# HISTORIC AND DESIGN REVIEW COMMISSION

January 20, 2016

**HDRC CASE NO:** 2015-376  
**ADDRESS:** 3006 BROADWAY  
**LEGAL DESCRIPTION:** NCB 3866 BLK 12 LOT 1, 2 & 3  
**ZONING:** C2 RIO-1  
**CITY COUNCIL DIST.:** 2  
**APPLICANT:** Edward Hernandez  
**OWNER:** Mauricio Marcushamer  
**TYPE OF WORK:** Final approval of new construction  
**REQUEST:**

The applicant is requesting conceptual approval to demolish an existing fast food restaurant and construct a new multi use structure to front Broadway.

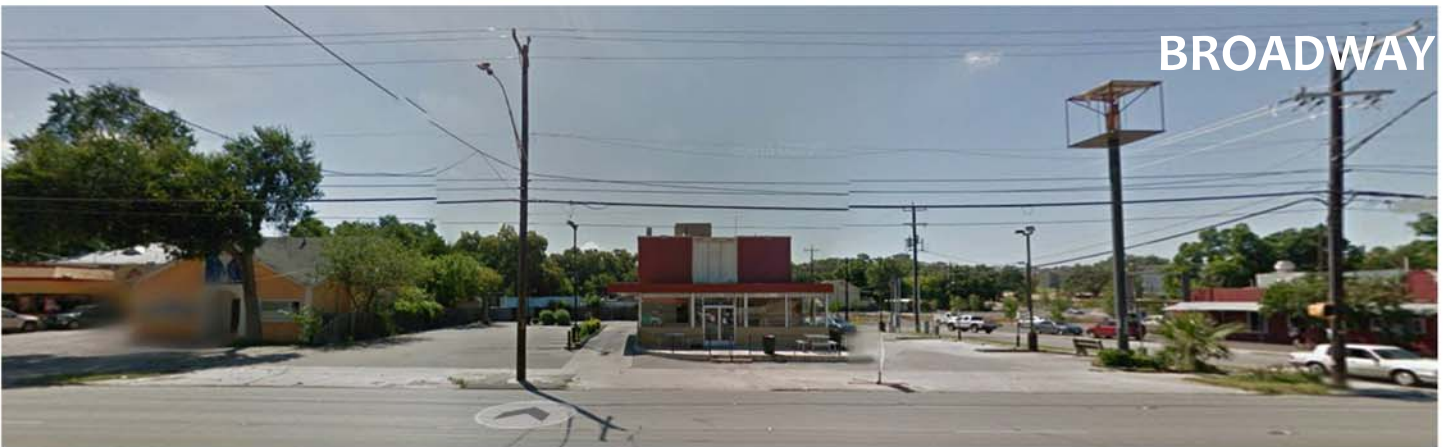
COMMENTS/CONCERNS: MG: LANDSCAPING MATERIALS AND PLAN  
ARE APPROPRIATE. LOCATING THE BUILDING AT THE ROW AT THE  
SIDEWALK IS APPROPRIATE AND CONSISTENT WITH THE UAL -- LEAVING  
EXAMPLE FOR BROADWAY. BF: THE TOWER WAS MORE APPROPRIATE  
ARCHITECTURALLY AT THE CORNER. MG: ADD SMALLER TOWER AT THE  
CORNER - POTENTIAL FOR ADDITIONAL ARCHITECTURAL FEATURE.

Provide PARAPET ALTERNATIVE

**SITE PLAN**

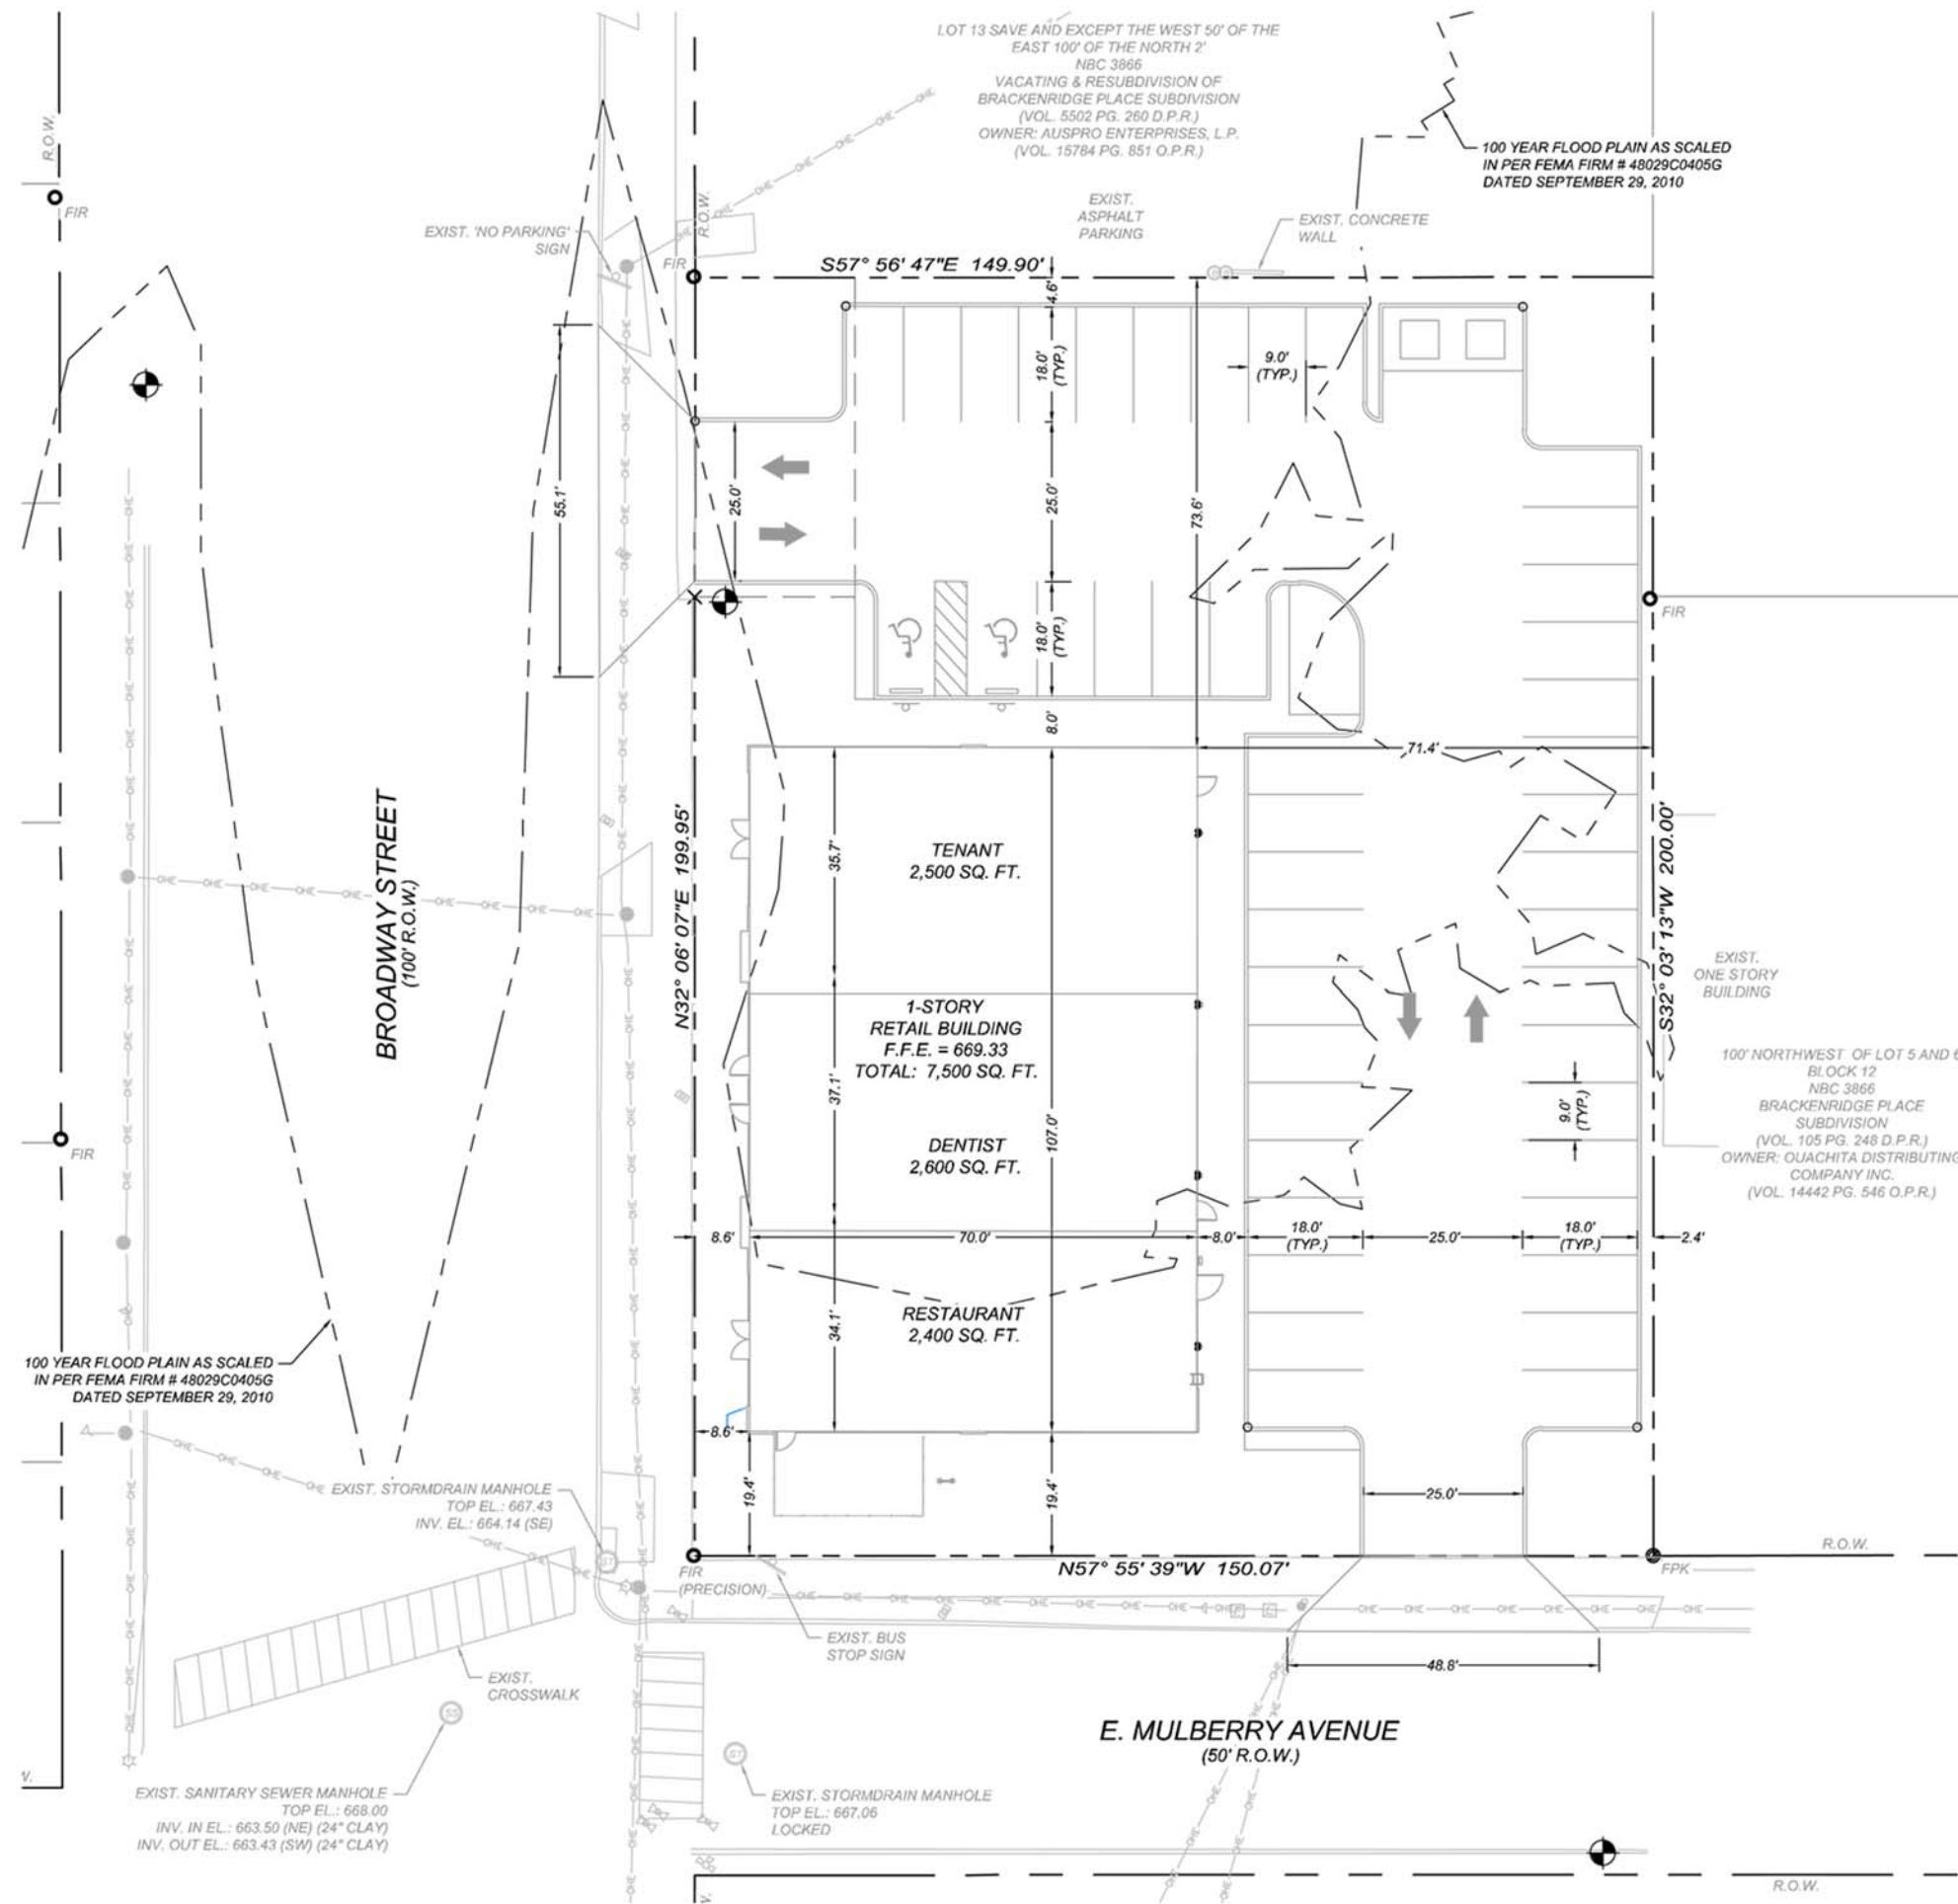
- b. Per the UDC Section 35-672(a) in regards to pedestrian circulation, an applicant shall provide pedestrian access among properties to integrate neighborhoods. The applicant has provided a site plan that has noted sidewalk connections across the property. This is consistent with the UDC.

- d. The applicant has sited surface parking to both the side and rear of the structure to be consistent with the UDC Section 35-672(b)(2). Per the UDC Section 35-672(b)(3), parking areas must be screened or buffered from view of public streets. The applicant has provided a detailed site plan noting parking buffering, planting materials and their locations. This is consistent with the UDC.
